CITY OF *Sunfish Lake* MINNESOTA

Planning Commission Findings of Fact & Recommendation (Approval)

Request: The applicants request City approval of major site and building plans and three conditional use permits to be able to construct a new home, garage, and pool terrace at 2566 Delaware Avenue.

RE: Sunfish Lake – Boyle – Major Plan Review and CUP; 2566 Delaware Avenue

UNDERGROUND STORAGE AREA X-SECTION

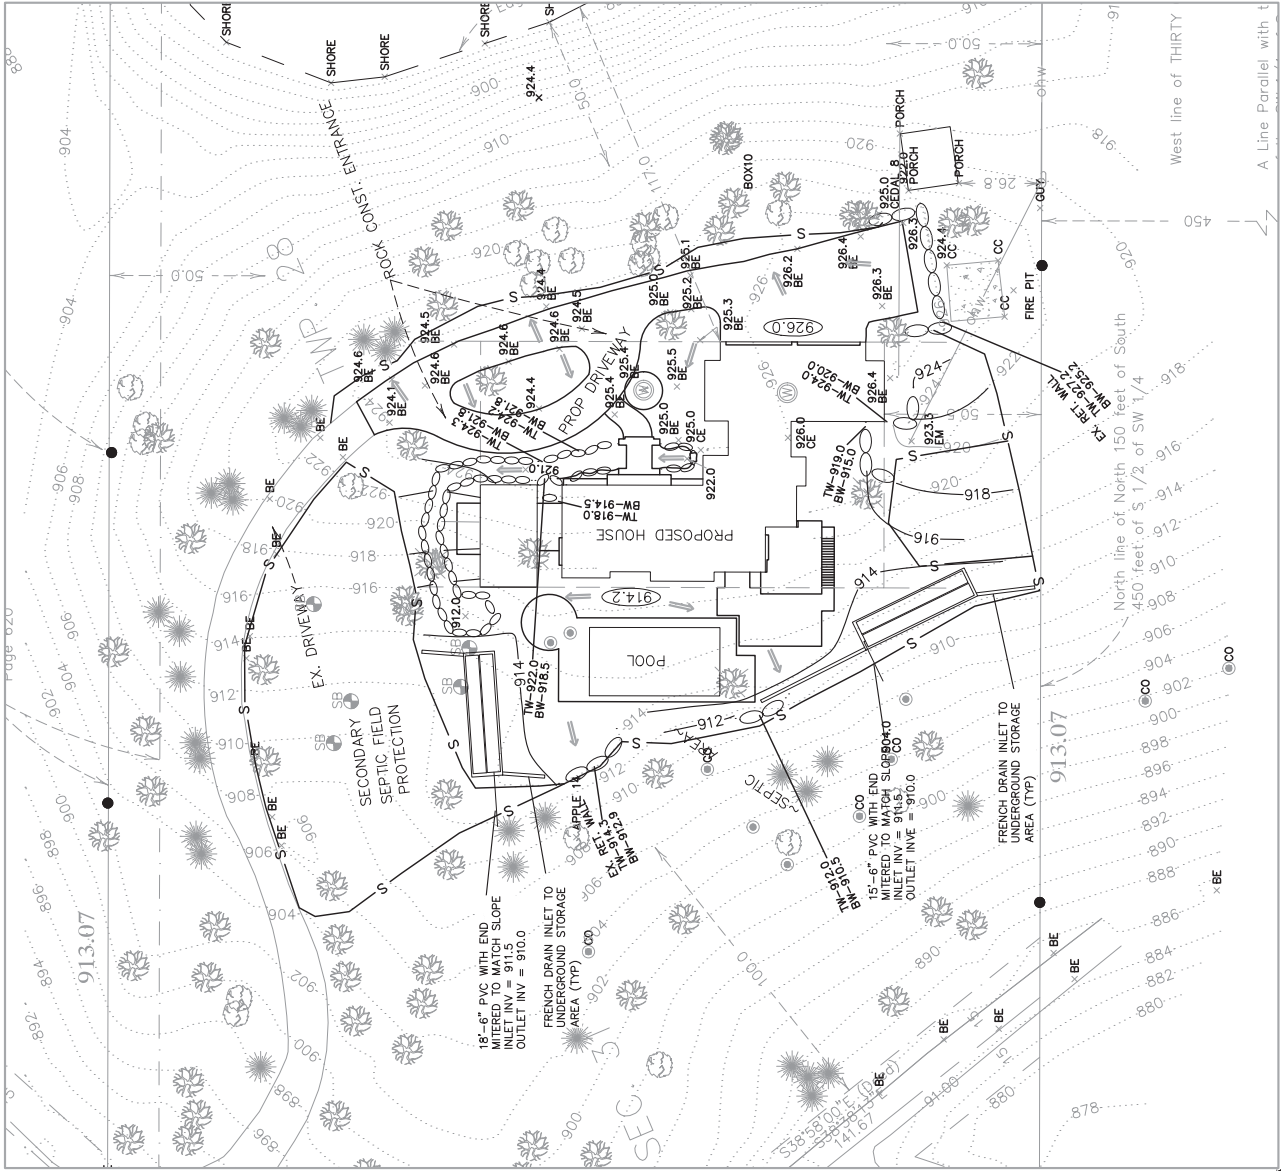
- The stormwater management plan provided did not include the entire modeling results of the proposed underground systems. The stormwater management plan will need to be

- The infiltration volume of the proposed underground system could not be verified. The entire modeling input and design of the systems is needed to verify the volume of water being trapped and infiltrated.

- How will the entire 100-year event runoff from the 21,300 sqft drainage area in the model be directed and intercepted by the underground systems? The grading plan should define the inlet locations and capacity to the underground systems. The drainage areas to each underground system should be delineated.

The stormwater management plan for the Boyle Property located at 2566 – Delaware is in conformance with the City policies and standards. The drainage and stormwater comments in the attached memorandum have been addressed.

FOR: CHARLES CUDD DENOVO, LLC
PROPERTY ADDRESS: 2566 DELAWARE AVENUE, SUNFISH LAKE, MN

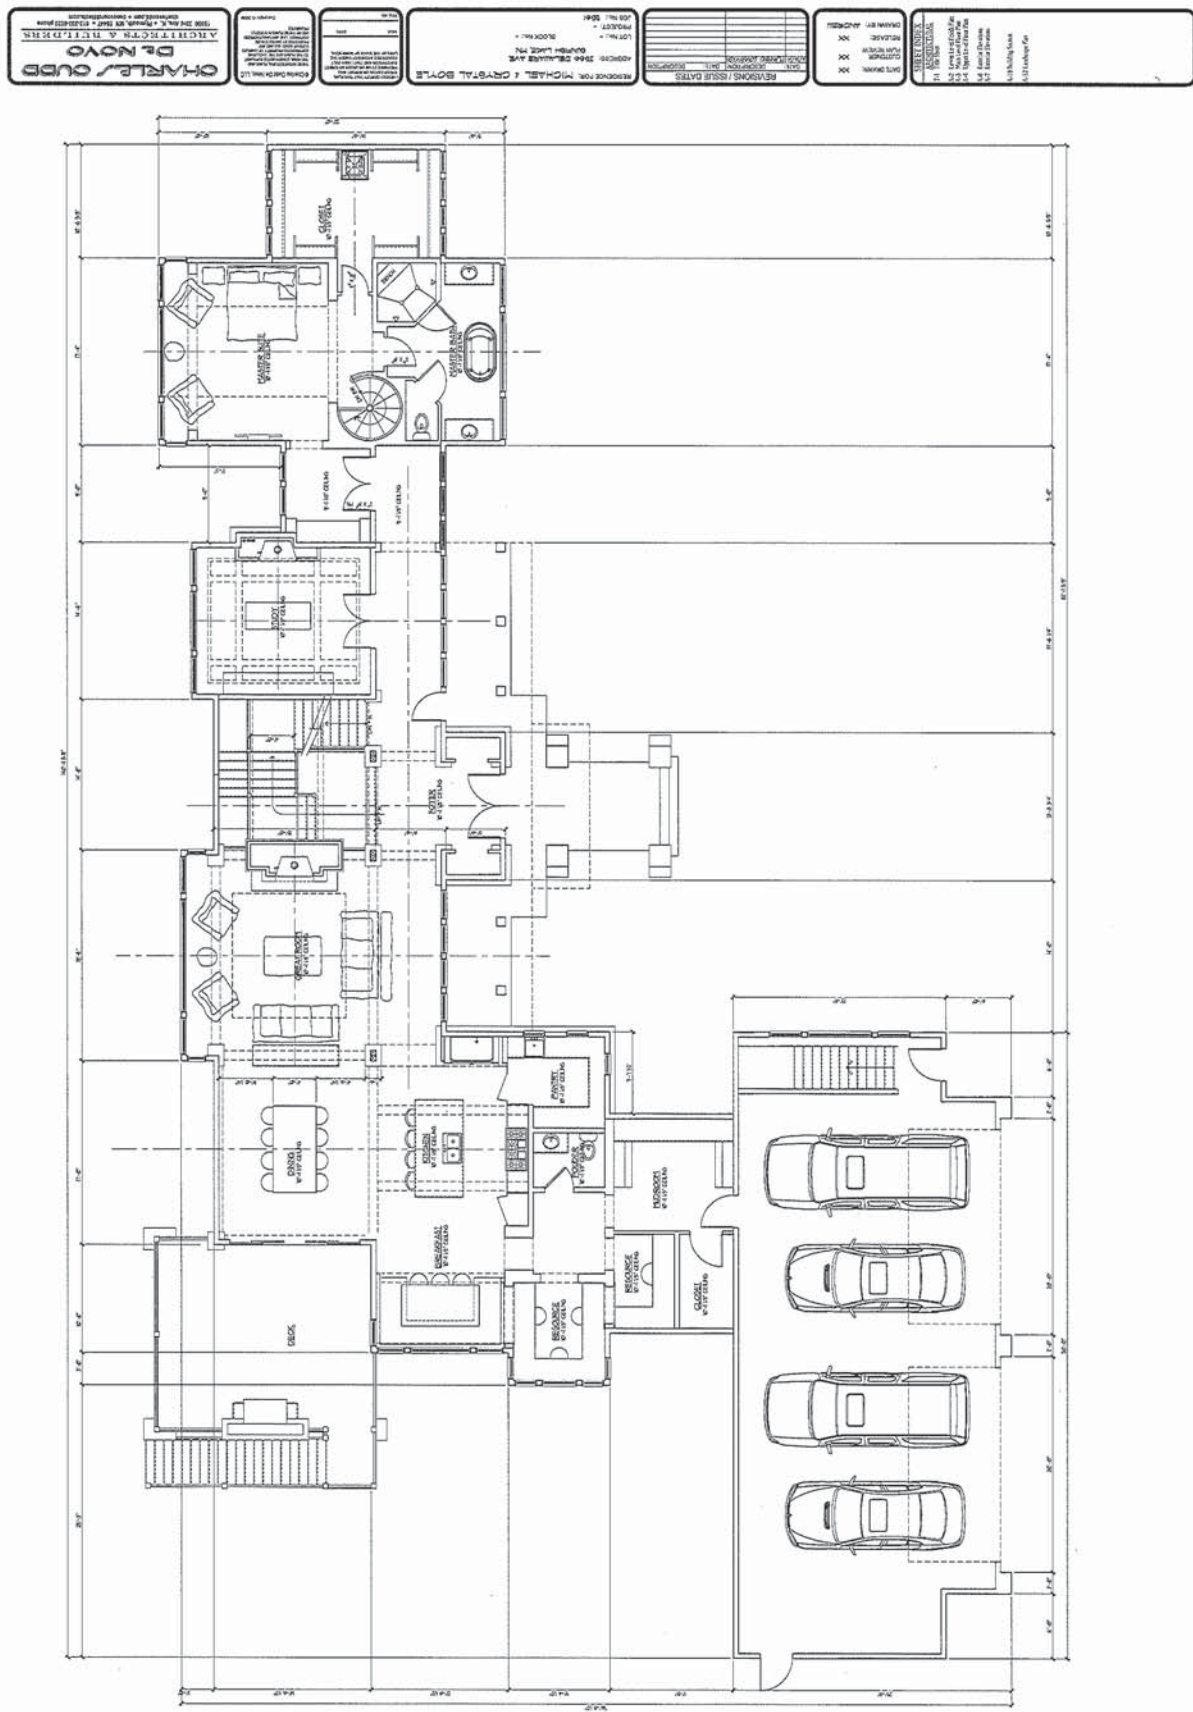
- The survey should show how the proposed construction will be impacting the site including trees which from the aerial photos it appears they will be removing.

- The setback line from Wood Duck Pond is determined from the delineated wetland line and NOT the survey shot of the water at the time of survey. This SB shown on their plans line is inaccurate and should be modified with a note on their assumption or deleted.

- Provide top and bottom wall elevations on all retaining walls. Some appear over 4' high and required to be designed by a professional engineer.
- Provide overall disturbed site area. If over an acre NPDES permit is required.
